PCD-ENGINEERING REVIEW COMMENTS
IN BLUE BOXES WITH BLUE TEXT

FINAL DRAINAGE REPORT
for
WINDERMERE FILING NO. 1

January 4, 2022

SF-21-026

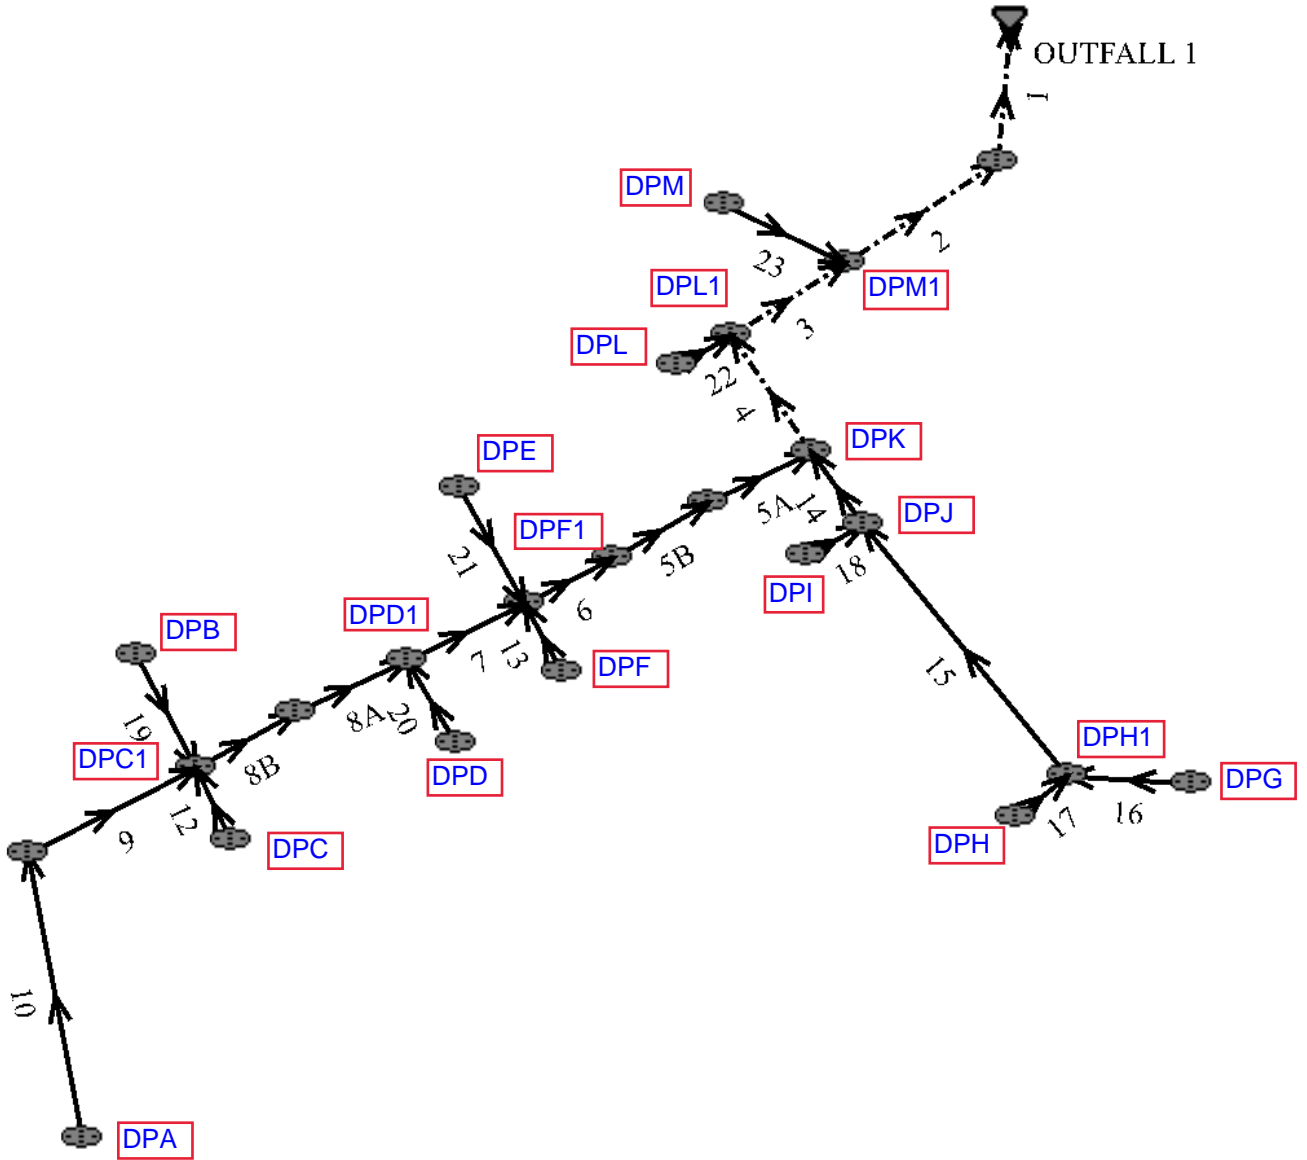
Include layouts for all storm systems

DETENTION BASIN OUTLET STRUCTURE DESIGN

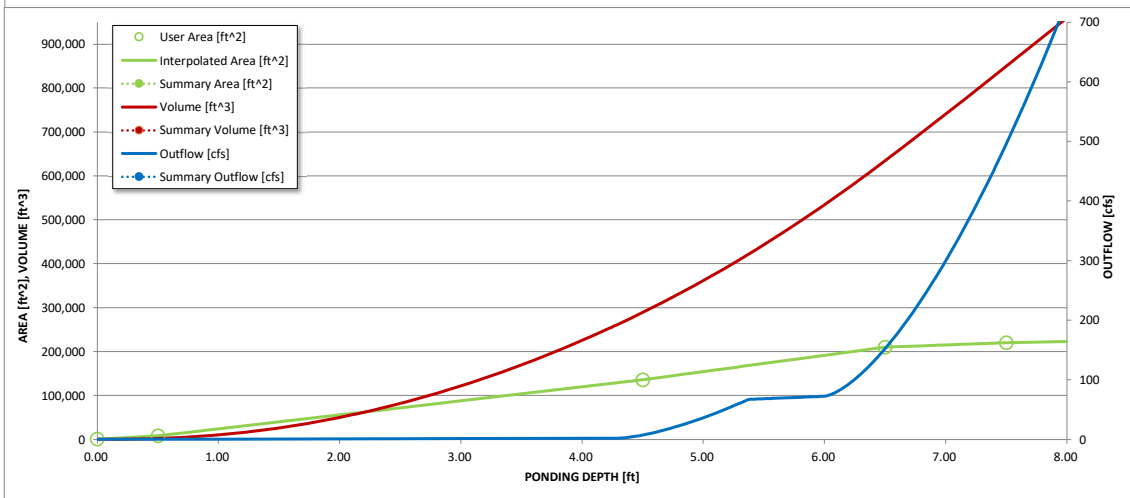
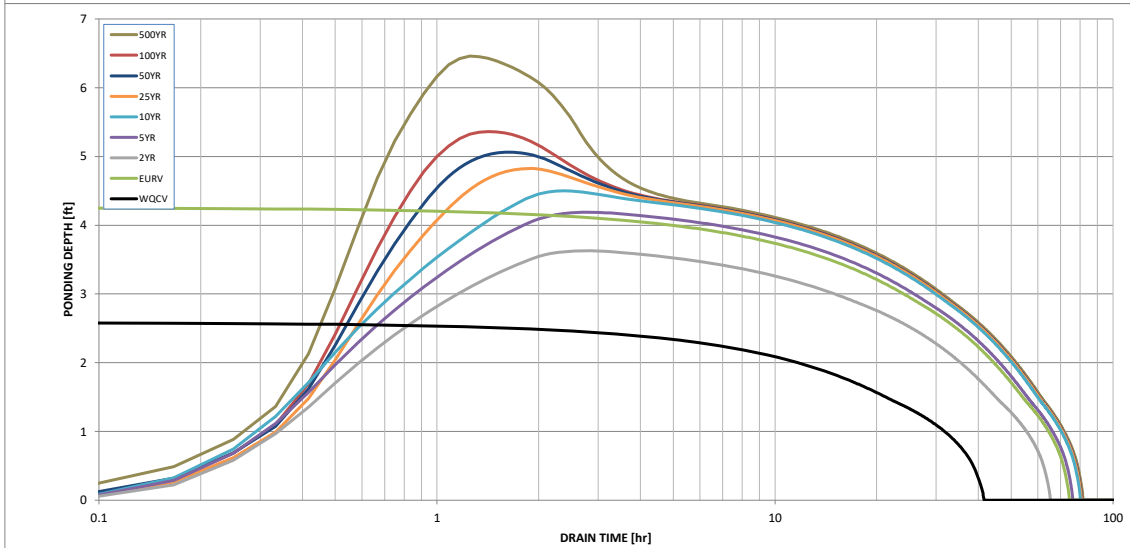
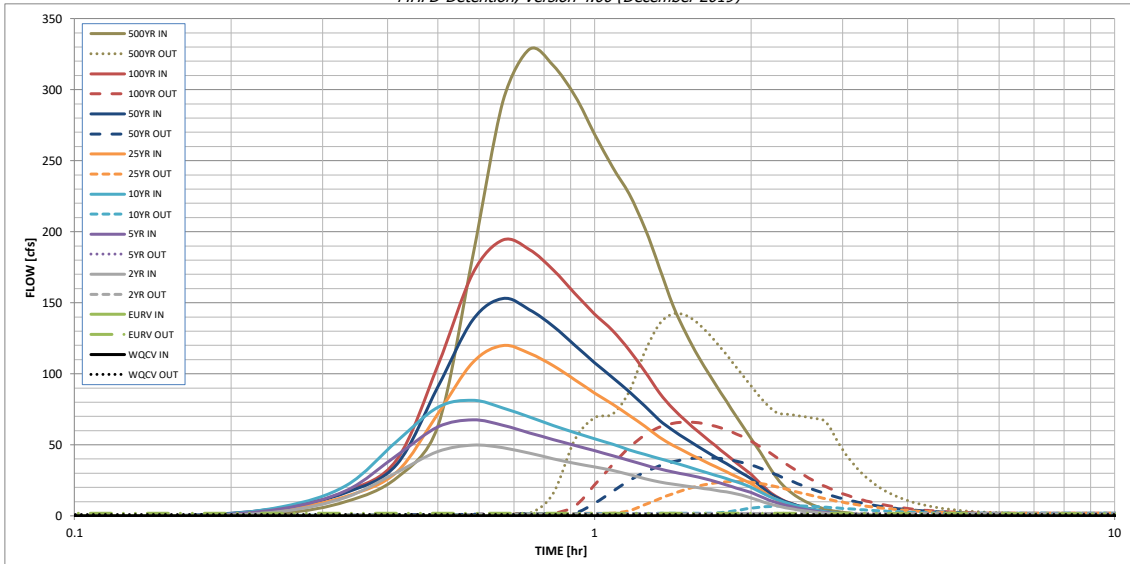
This should be ~1 Small adjustment to overflow weir elevations should get to the requirement

DR1

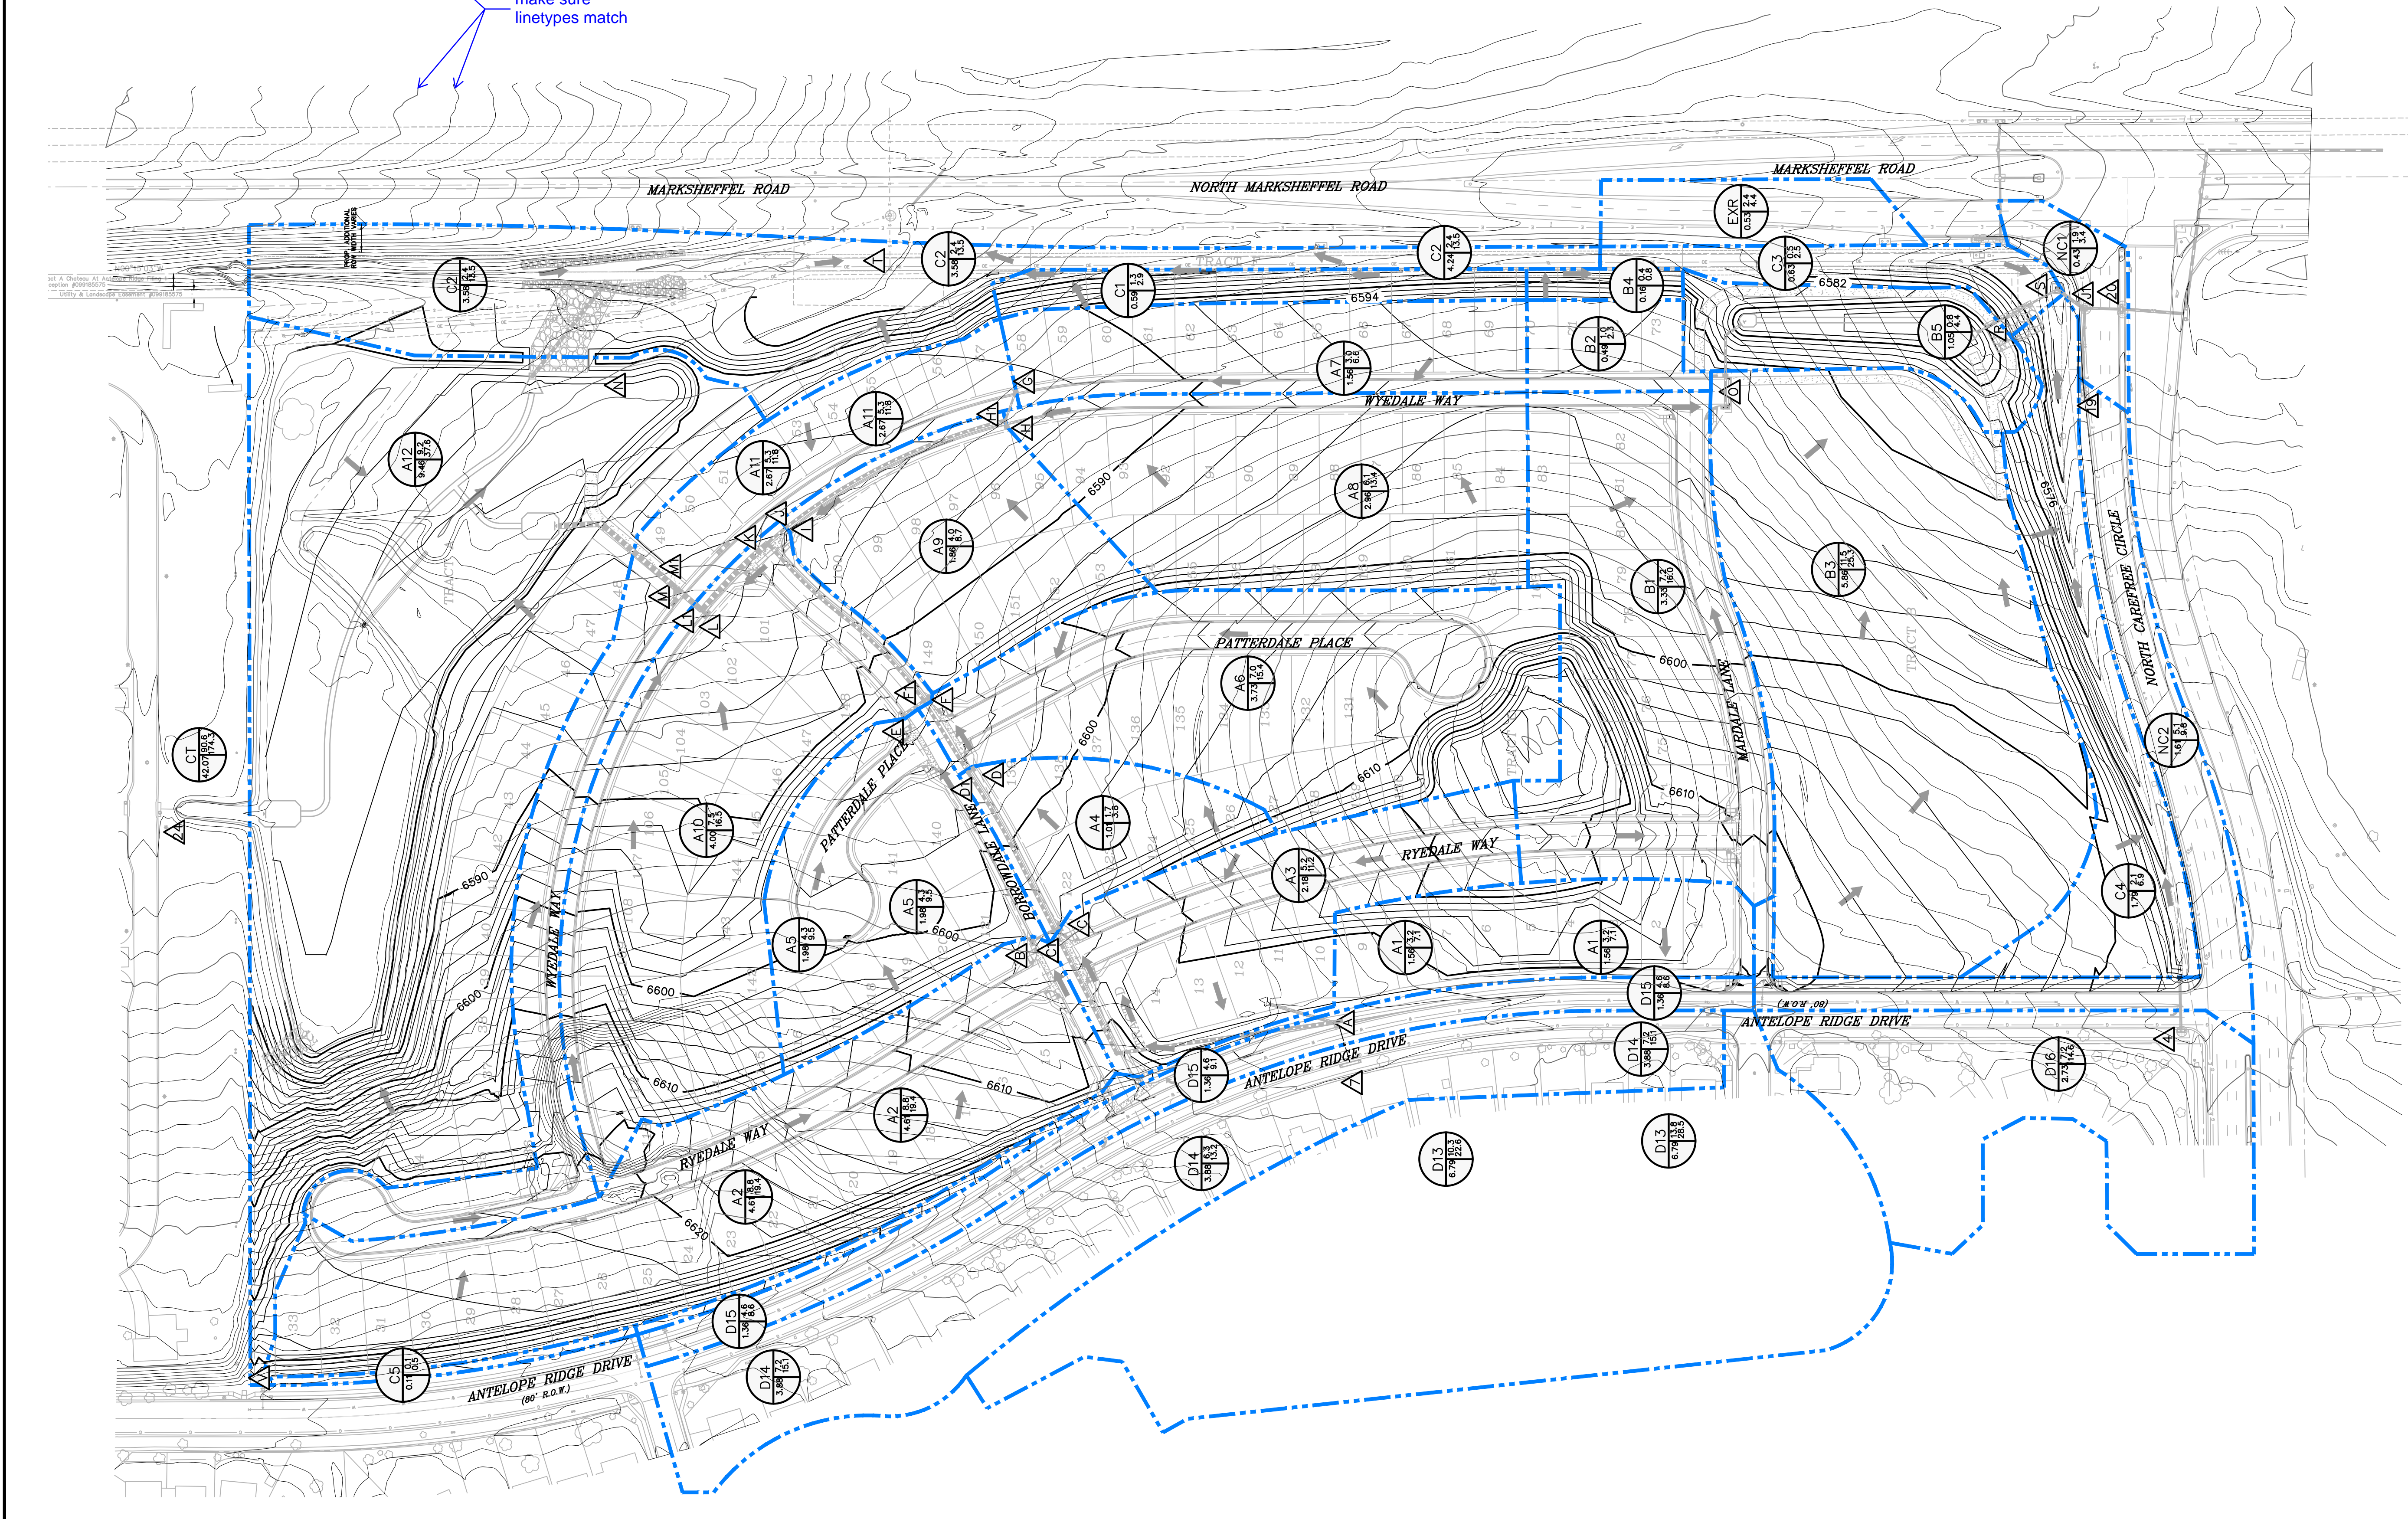
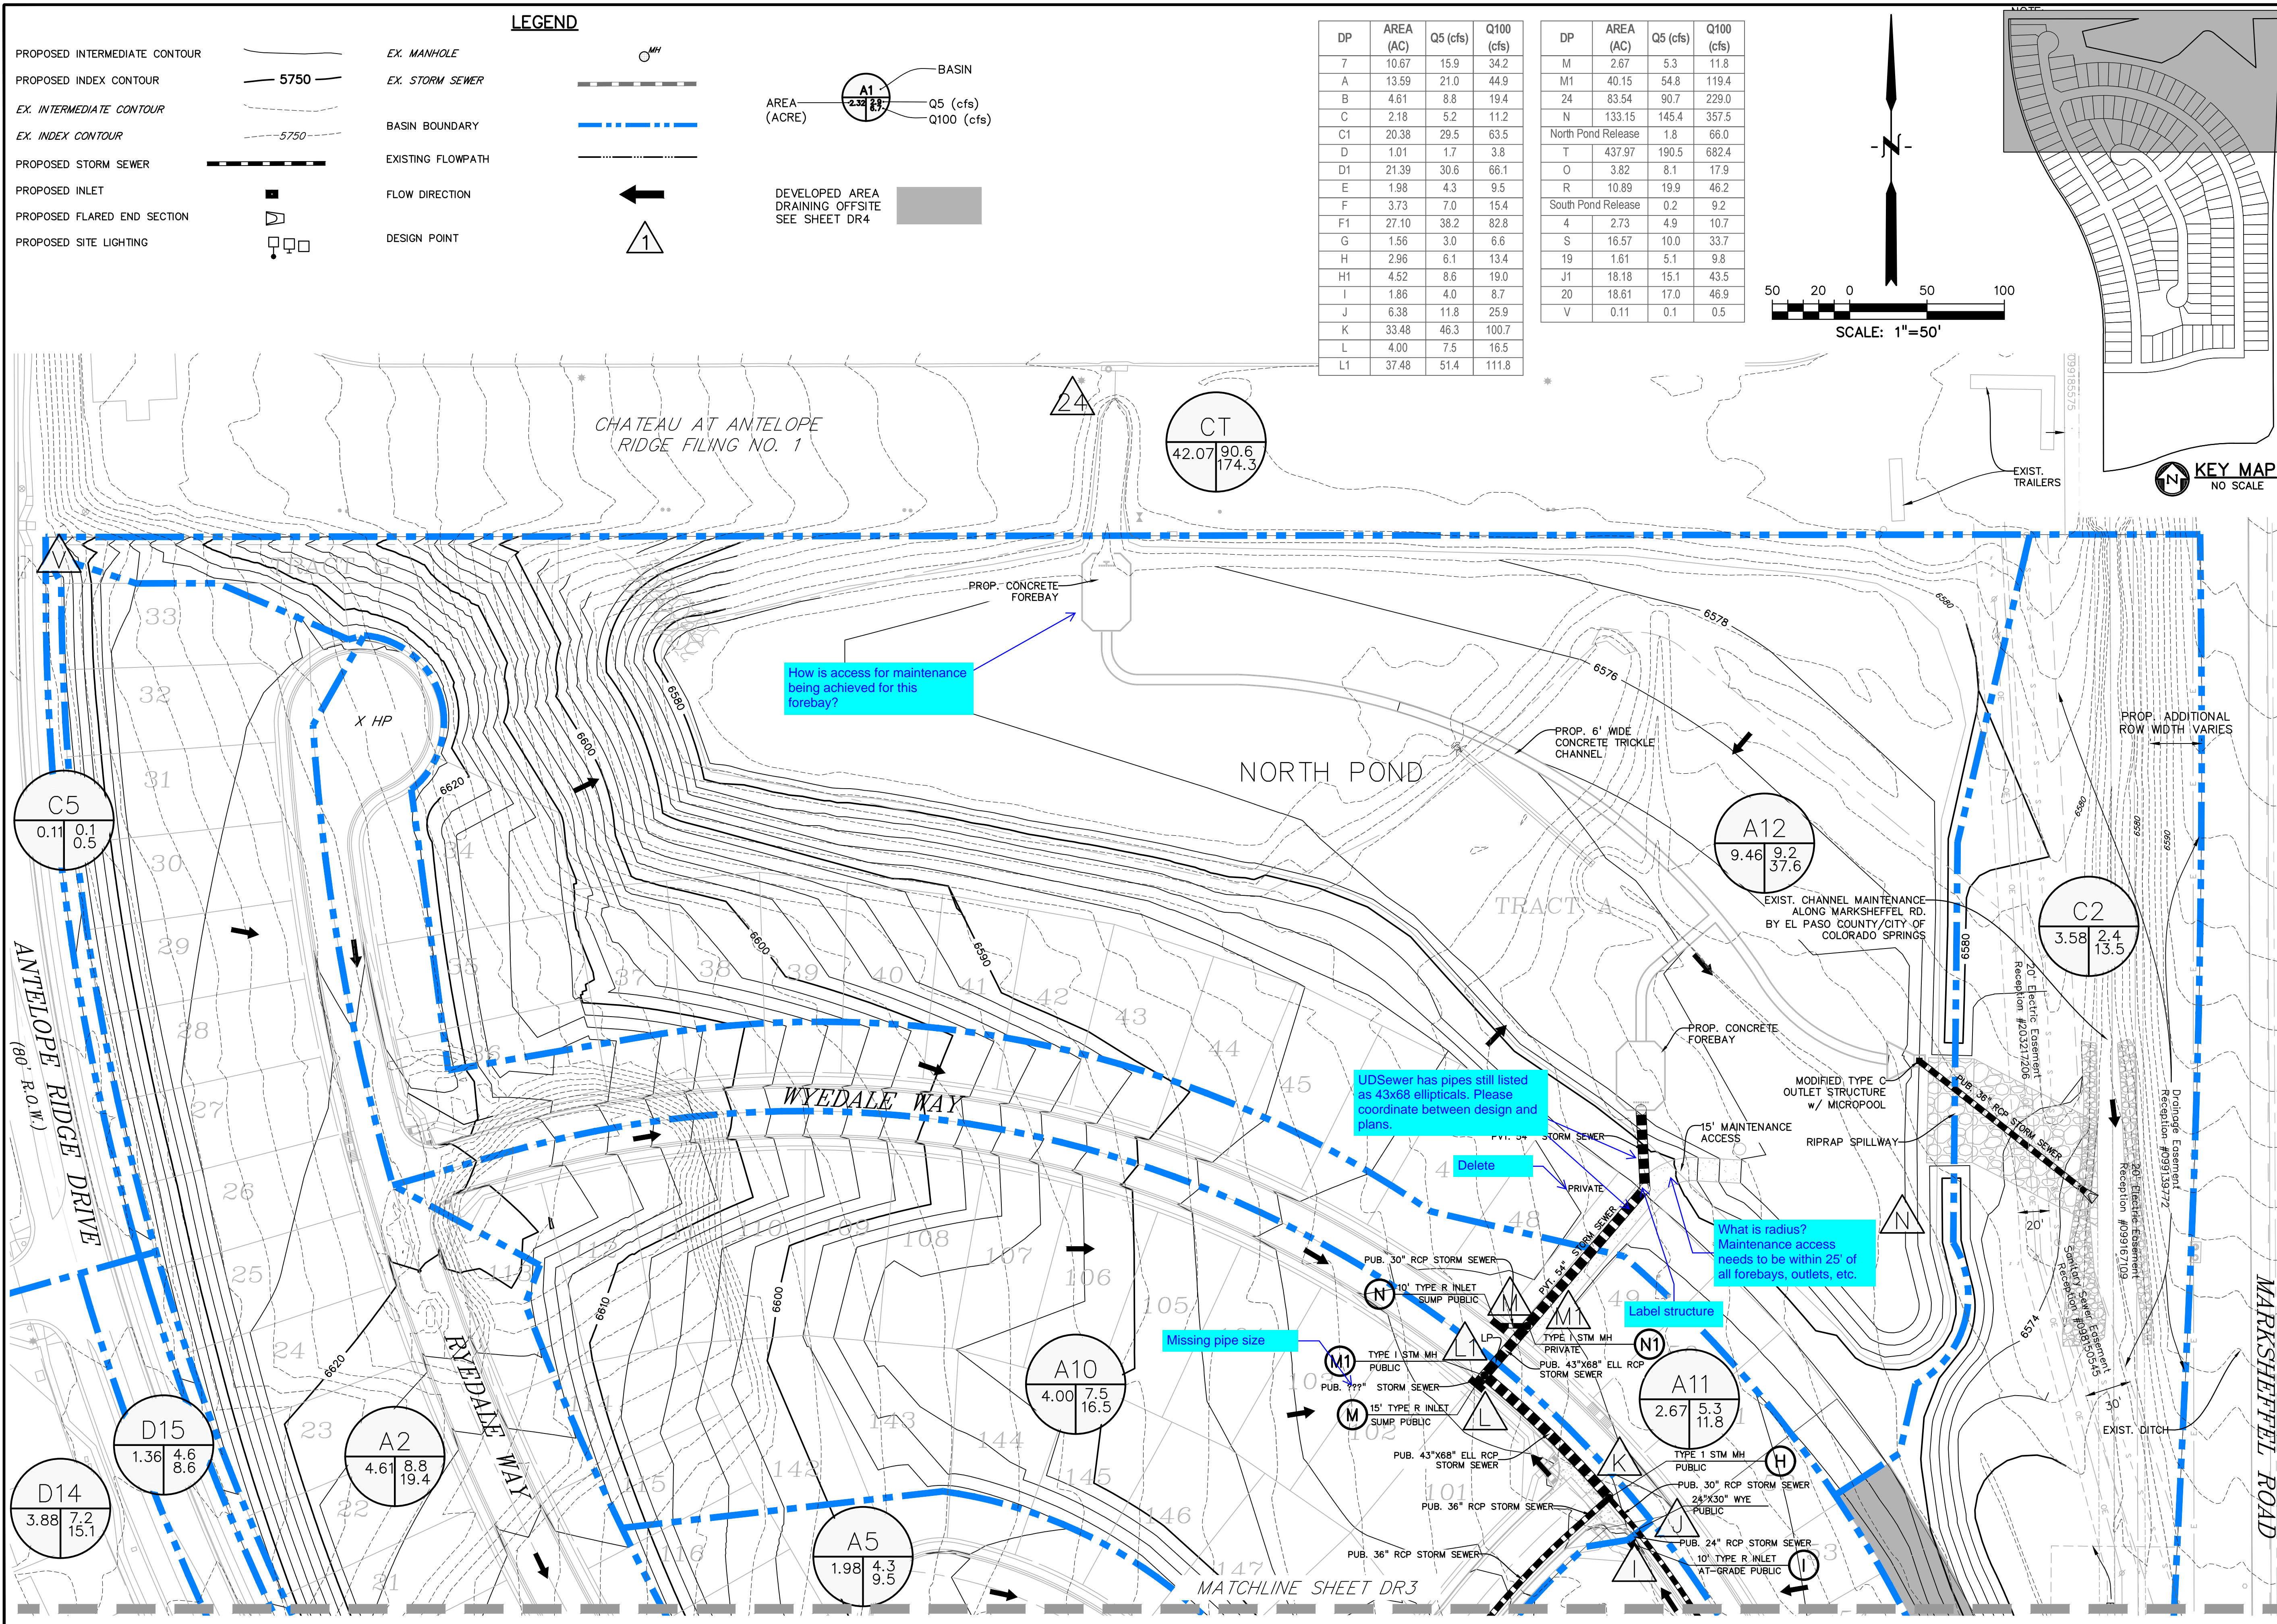
Add additional contour labels for existing and proposed contours
